Re: Cabrillo Parkway

This letter is in response to Caltrans' concerns regarding potential historic impacts of the proposed Plaza de Panama project on the locally and state-listed Cabrillo Parkway (SR 163) that runs through Balboa Park. Cabrillo Historic Parkway was designated a California Scenic Parkway in 1992. In 1996, parts of SR 163 were designated a California Register historic district. The boundaries of this district encompass the Caltrans right-of-way (ROW) through Balboa Park from a point roughly 300 feet south of Cabrillo Bridge to a point just south of the 6<sup>th</sup> Avenue on-ramp. The ROW is approximately 187' wide, including shoulders on either side of the roadway that are approximately 75' wide. These boundaries extend vertically into the air at a perpendicular angle to encompass the central arched viaduct portion of Cabrillo Bridge. According to the 2011 SR 163 Transportation Concept Summary the California Register historic district includes the following features:

HISTORIC RESOURCES TECHNICAL REPORT  
**BALBOA PARK**

Existing Condition, Centennial Bridge not Visible

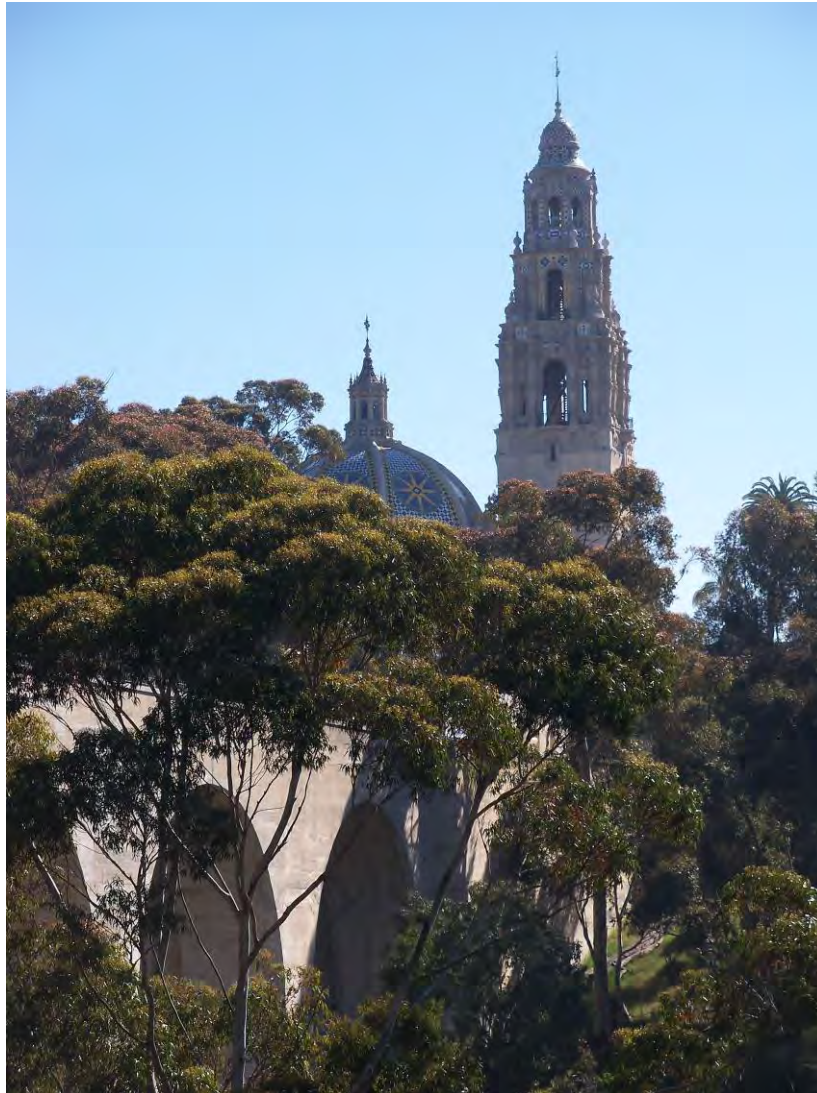
- The attached visual mock-ups prepared by Heritage Architecture & Planning and published in the Draft Environmental Impact Report (DEIR) indicate that the new work proposed as part of the Plaza de Panama project would not be visible from the roadway of SR 163, avoiding any significant visual impacts. Indeed, the photo-simulations in the DEIR show that the proposed Centennial Bridge and, in particular, the intersection of Centennial Bridge and Cabrillo Bridge would not be visible from SR 163.
